**ADDENDUM NO. 1**

**RE: Grayson County Water District  
Office & Utility Building  
21 Shull White Road  
Leitchfield, Kentucky 42754  
Project No. 16123**

**May 24, 2017**

DWV ISOMETRIC DIAGRAM  
SCALE: NONE

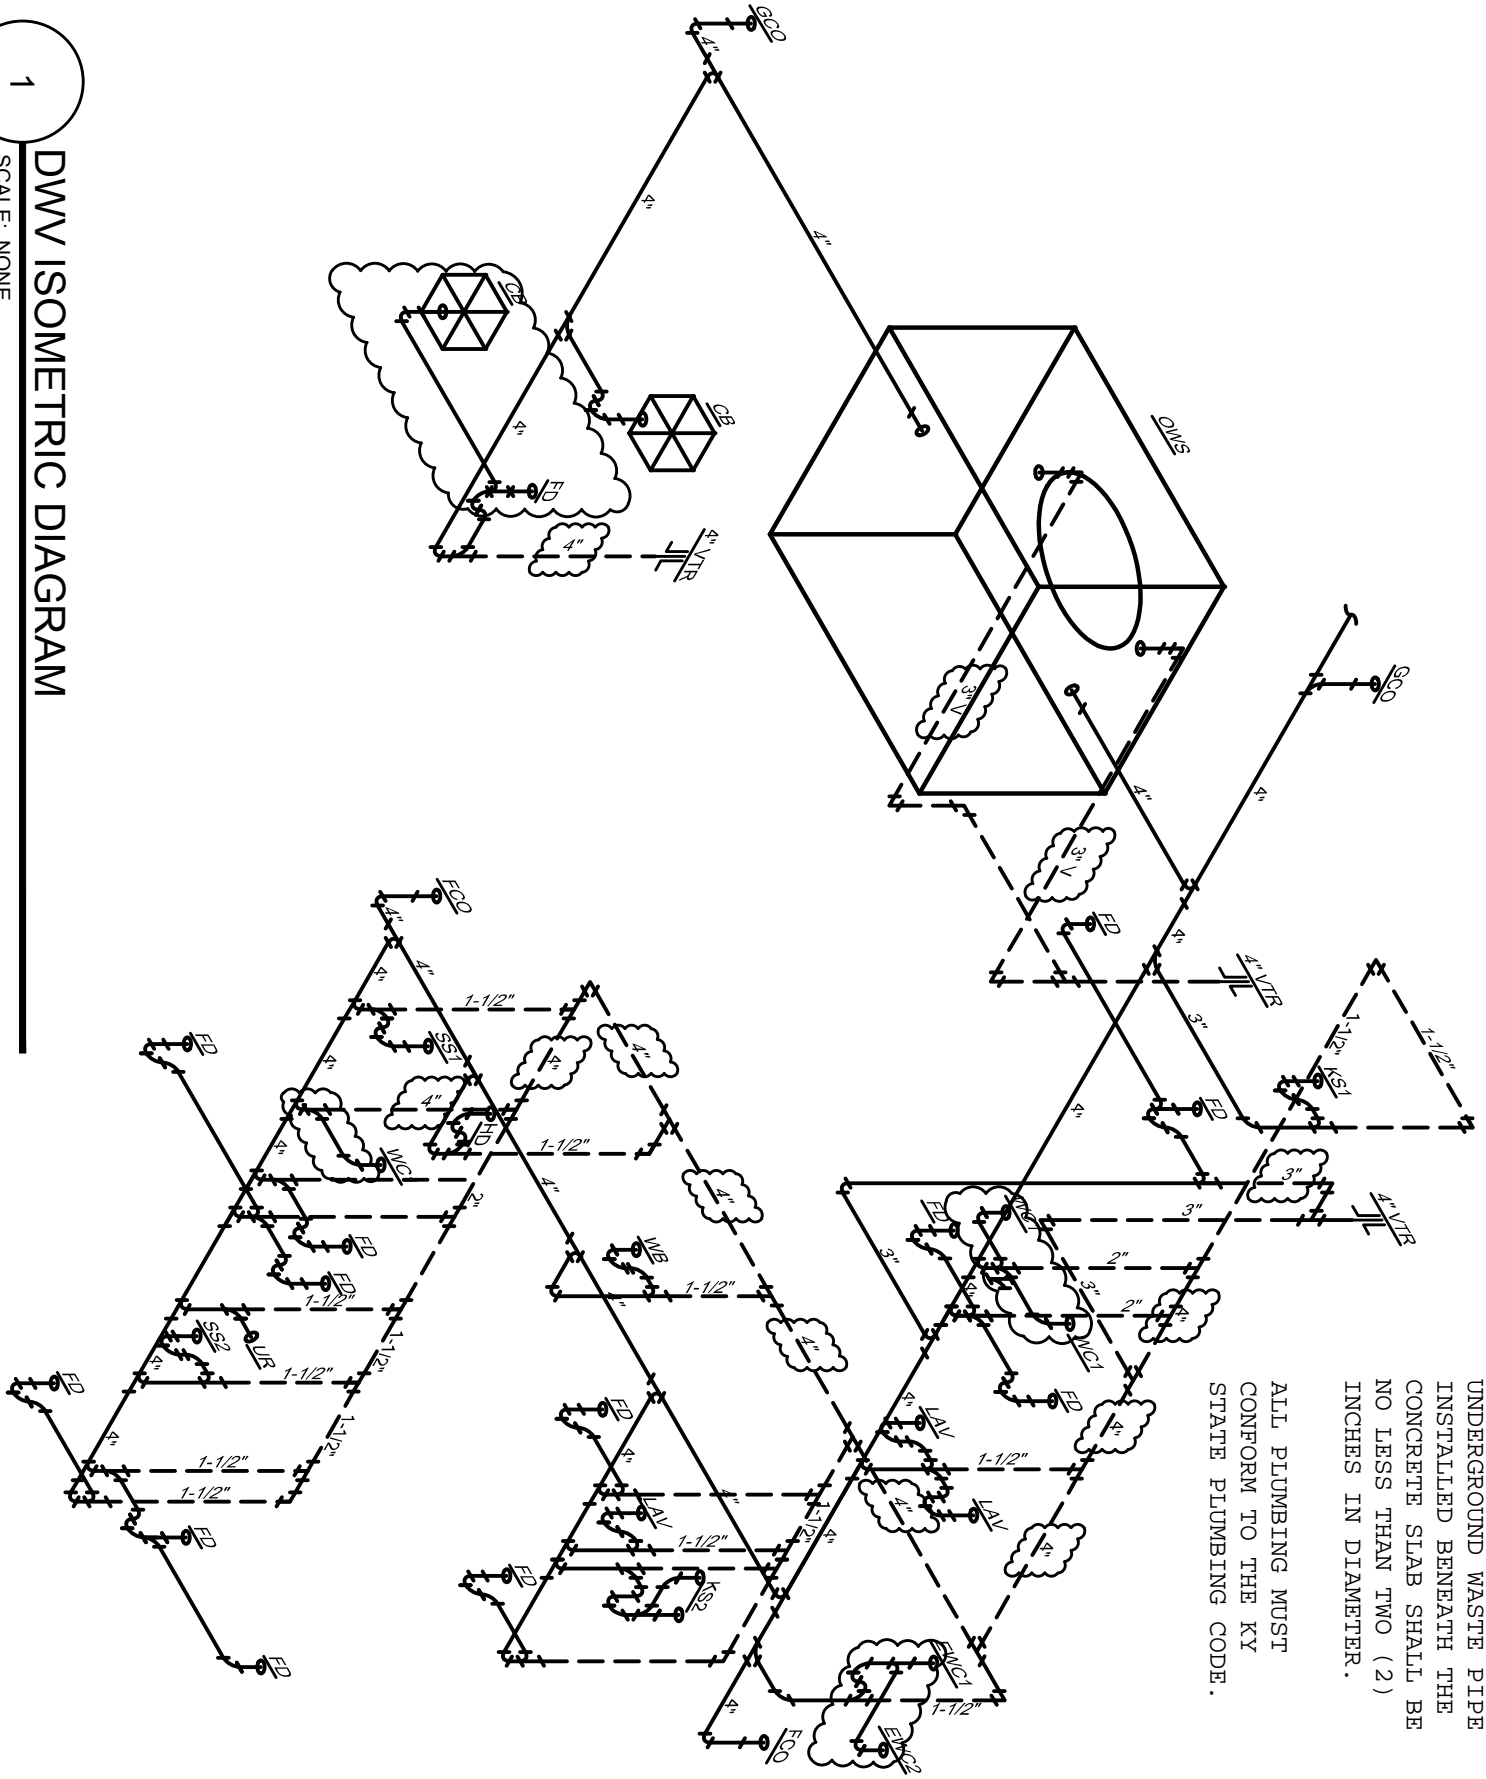
- 7. **P-501 Plumbing Details**
  - A. Refer to attachment ADD 1.2 for the revised DWV Isometric Riser Diagram.
- 8. **E-001 Site Electrical Plan**
  - A. Provide (3) #6 CU. and (1) #8 CU. GND in 1" conduit from panel P1 to panel P3 (Main Building to Utility Building) as indicated on Single Line Riser Diagram C3/E-601. Service connection is to be routed below grade.
